City of Santa Fe, New Mexico

memo

Case #2016-51. Haciendas Del Mirasol, 700 Hyde Park Road, Preliminary Subdivision Plat. Cody North, agent for 700 HRP, LLC, requests preliminary subdivision plat approval for 8 lots on 28 acres to be accessed by a private driveway via a connector road off of Hyde Park Road. The property is zoned PRC (Estancia Primera Planned Residential Community). (Donna Wynant, Case Manager)

SHEET 2-4

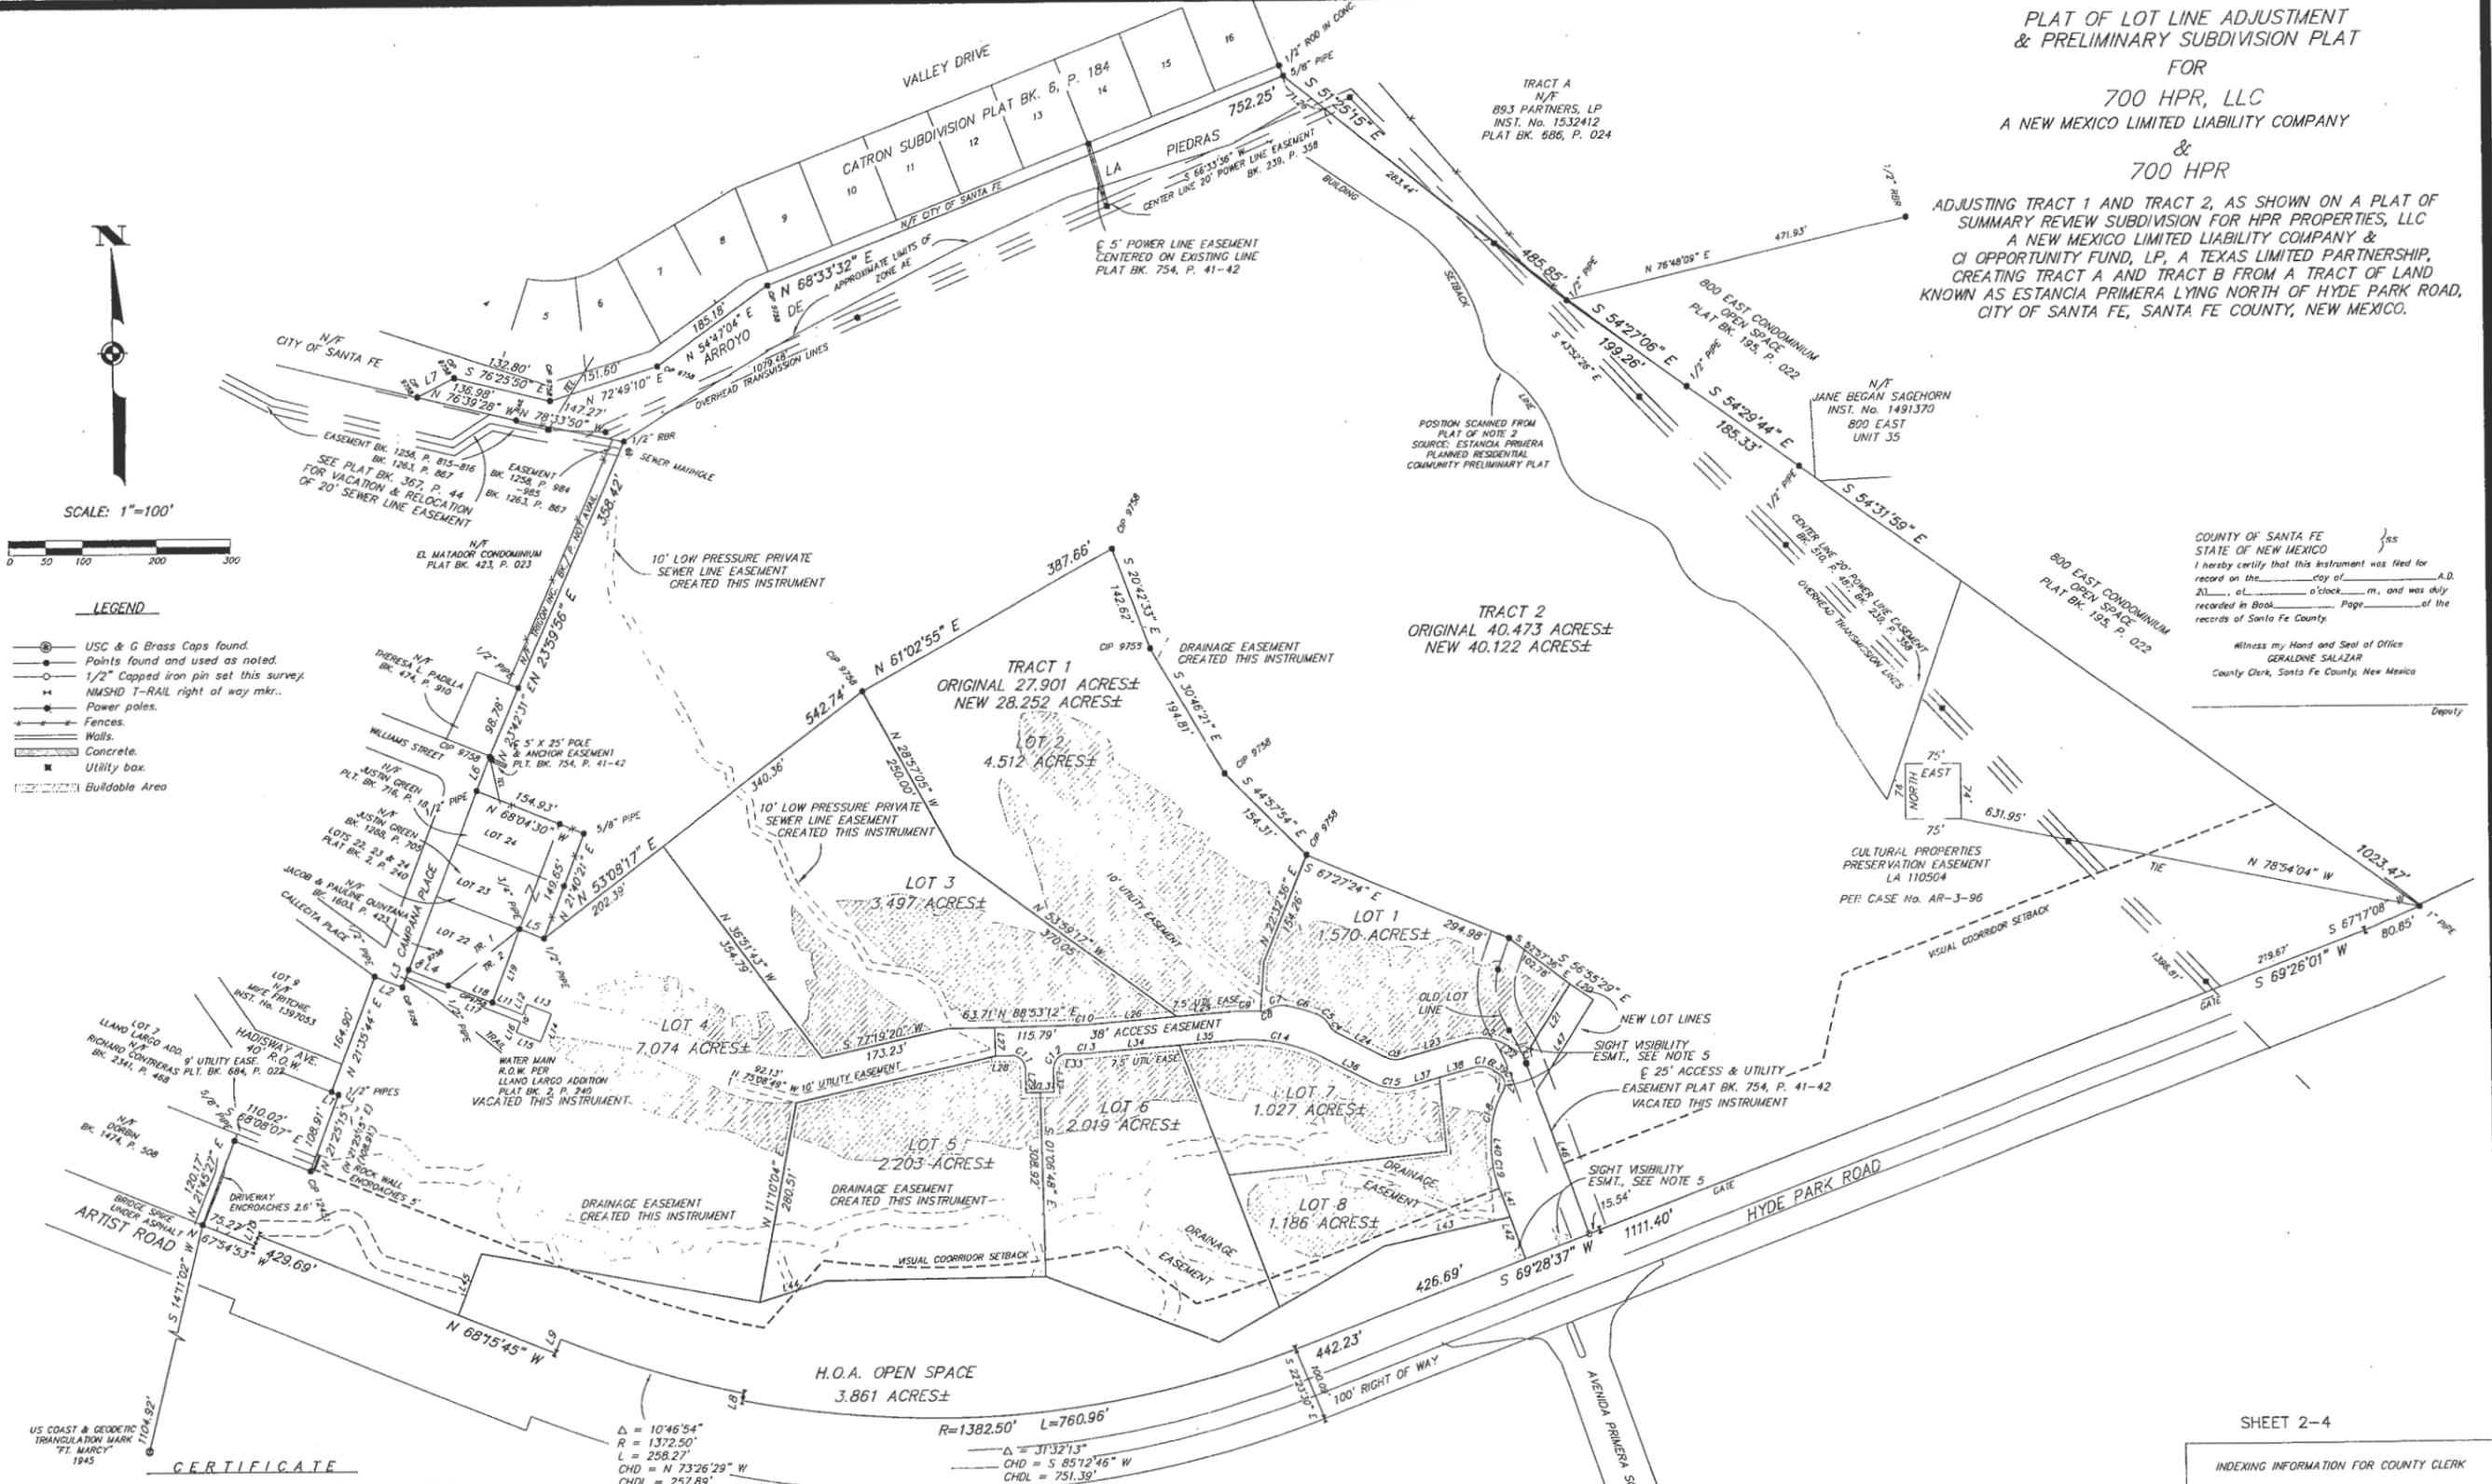
1 Show foothills and ridgetop subdistricts on PLAT

2 Add notarized stormwater agreement to PLAT

Technical Corrections*:	Must be completed by:
1. Add note to the plat that Wastewater Utility Expansion Charges (UEC) shall be paid at the time of building permit application.

2. Add note to the plat stating that no fences, walls, or other obstructions shall be placed or constructed across or within public sanitary sewer or utility easements

3. Add note to the plat that the Development is served by a private sewer system	
4. Add note to the sewer utility sheet that the connection to the existing public sewer manhole shall be core drill
